Design Compliance Report

Schematic Design Review

Ulladulla High School Upgrade , 55 South Street Ulladulla NSW

Report Number & Revision:	**MSA2678_BCA_ULL_A_2.3**
Prepared For:	**NSW Department of Education (DoE)**
Date of Issue:	**19th March 2025**

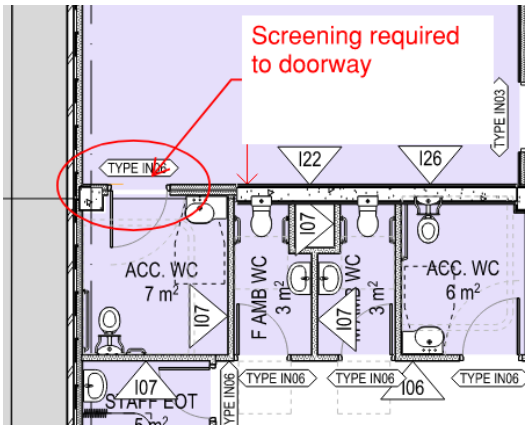
#	DTS Clause	Recommendation	Status
•	D6D9	**Restriction on the Position of Water closets and Urinals (Airlocks)** The accessible toilet facility on ground floor level opens directly into the general learning space without being adequately screened from view which does not satsify BCA Clause F6D9 and F6D10

The absence of an airlock or screen to the facility will require support under a **BCA Performance (Alternative) Solution** (F6P4)**.** Evidence is to be supplied from the school confirming the supervision needs of the students using the support learning facility are comparable to those of other facilities which do not require screening.	**BCA Performance Solution**

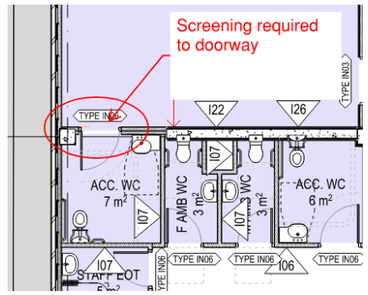
BCA 2019 Cl.	BCA 2022 Cl.	BCA Requirement	Compliance Comment	Status
F4.7	F6D8	**Ventilation borrowed from adjoining room** Natural ventilation can be borrowed from an adjoining room providing adjacent room is provided ventilating area that is 5% (or 10% in Class 5-9 buildings) of the both the subject room and the adjoining room combined.	Borrowed natural ventilation is not currently relied upon.	**Certification by Designer or Specialist**
F4.8	F6D9	**Restriction of position of water closets and urinals** Generally sanitary compartments must <u>not</u> open directly into: • A kitchen, pantry, public dining area or restaurant • Dormitory in a Class 3 building • Room / area used for public assembly • Workplace normally occupied by more than 1 person *Note comments in F4.9 below.*	The accessible toilet facility on ground floor level opens directly into the general learning space without being adequately screened from view which does not satisfy BCA Clause F6D9 and F6D10

The absence of an airlock or screen to the facility will require support under a **BCA Performance (Alternative) Solution** (F6P4)**.** Evidence is to be supplied from the school confirming the supervision needs of the students using the support learning facility are comparable to those of other facilities which do not require screening.	**BCA Performance Solution**
